DESIGN CHANGES INCORPORATED BY REFERENCE	
DOCUMENT NO	DOCUMENT NO
24590-WTP-FC-C-12-0325

RIVER PROTECTION PROJECT
 WASTE TREATMENT PLANT
 2435 STEVENS CENTER PLACE
 RICHLAND, WA 99354
 CONTRACT No: DE-AC27-01RW14136

LAW VITRIFICATION BUILDING
GENERAL ARRANGEMENT
PLAN AT EL. 48'-0"

PLAN AT EL 48'-0"

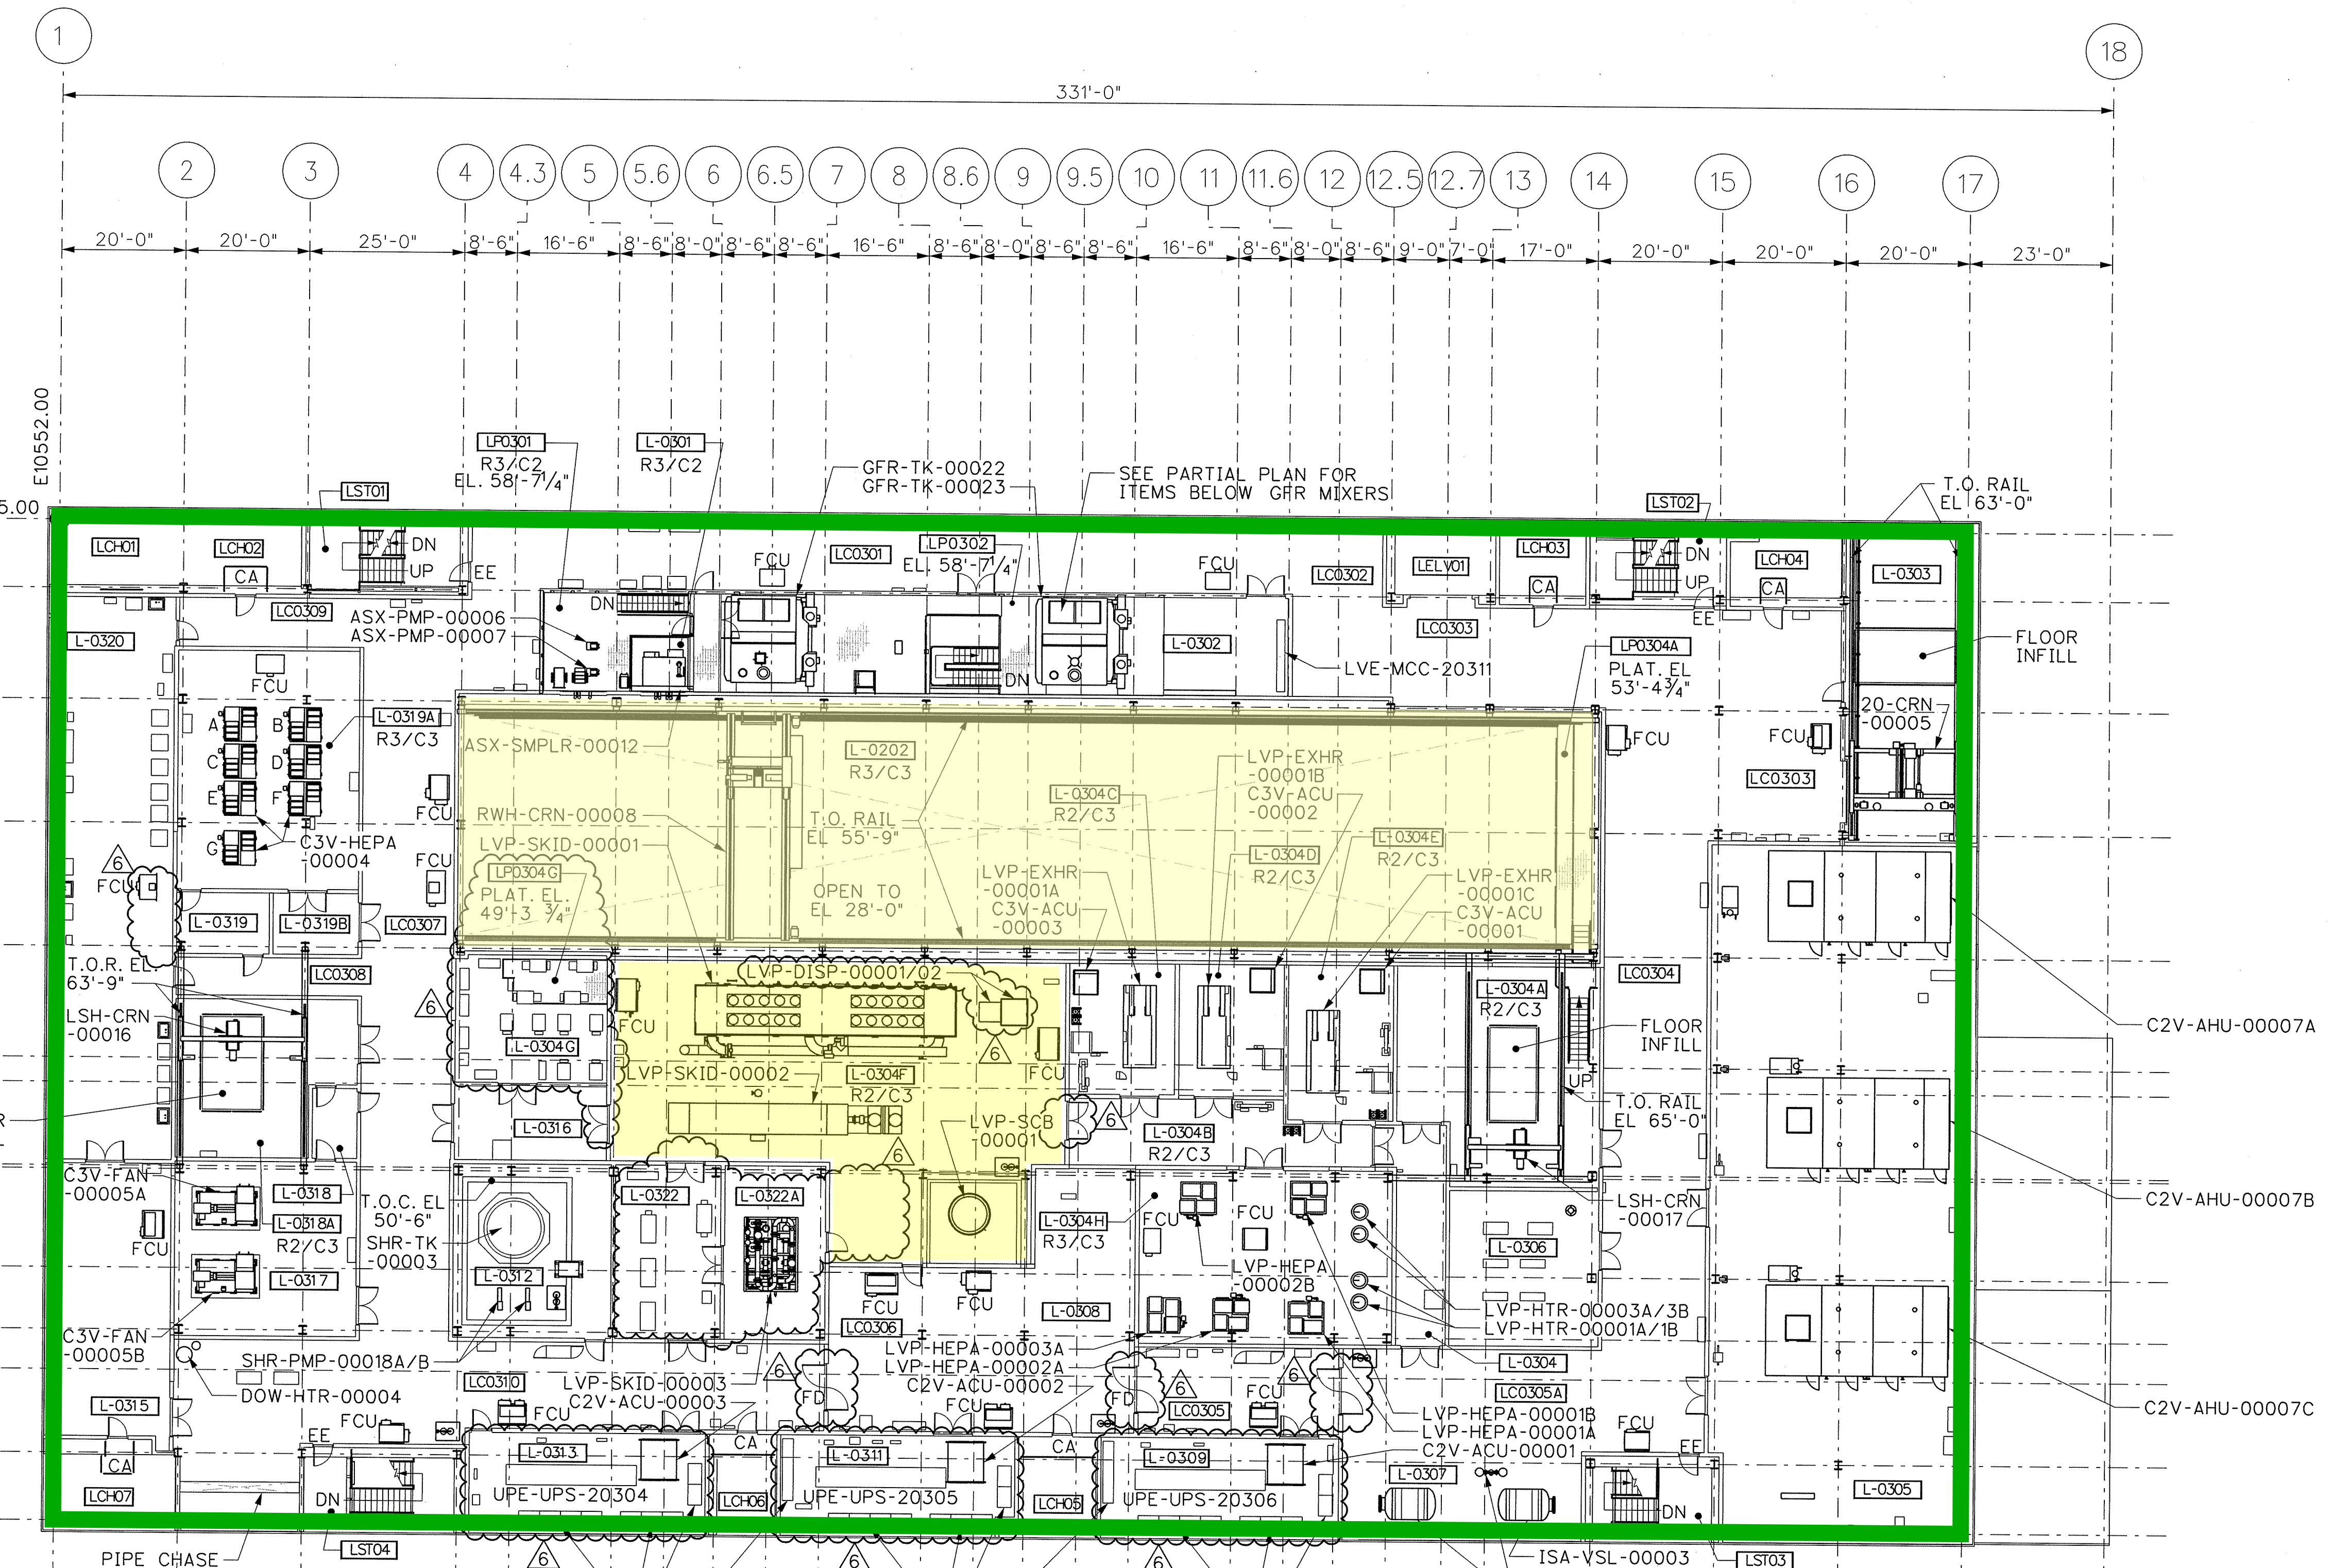
- SEE NOTE 6 ON REV 5 OF THIS DRAWING FOR REV 5 HISTORY.
 - REVISED TO INCORPORATE THE FOLLOWING:
 - 24590-LAW-PIN-P01T-00070: REVISED FCU IN L-0320.
 - 24590-LAW-PIN-P01T-00073: REVISED C2V-ACU-00001/02/03.

- 24590-LAW-PIN-P01T-00075: REMOVED HOLD 19 FROM LVP-EXHR-00001A/B/C.
 - 24590-LAW-PIN-P01T-00076: PARTITIONED L-0322 TO ADD L-0322A.
 - 24590-LAW-PIN-P01T-00077: ADDED LVP-DISP-00001/02.

- 24590-LAW-PIN-P01T-00079: REVISED UPE EQUIPMENT.
 - 24590-LAW-PIN-P01T-00080: DELETED SECTION CUT SYMBOLOLOGY.
 - 24590-LAW-PIN-P01T-00083: ADDED LPO304G. DELETED DOOR ON EAST WALL OF L-0304G. REVISED DOOR ON EAST WALL OF L-0316.

- 24590-LAW-AIN-A10T-00089: REVISED DOORS AND WALL IN LCO305 AND LCO306.
 - 24590-LAW-AIN-A10T-00089: REVERSED DOOR SWING DIRECTION ON WEST WALL OF L-0304B.

- REVERSED DOOR SWING DIRECTION ON NORTH WALL OF L-0322.
 - DELETED HOLD 19. HOLDS ARE NO LONGER TRACKED ON GA DRAWINGS.
 - REVISED TITLE BLOCK.
 - ADDED NOTE 7. REVISED NOTES 3 AND 6.
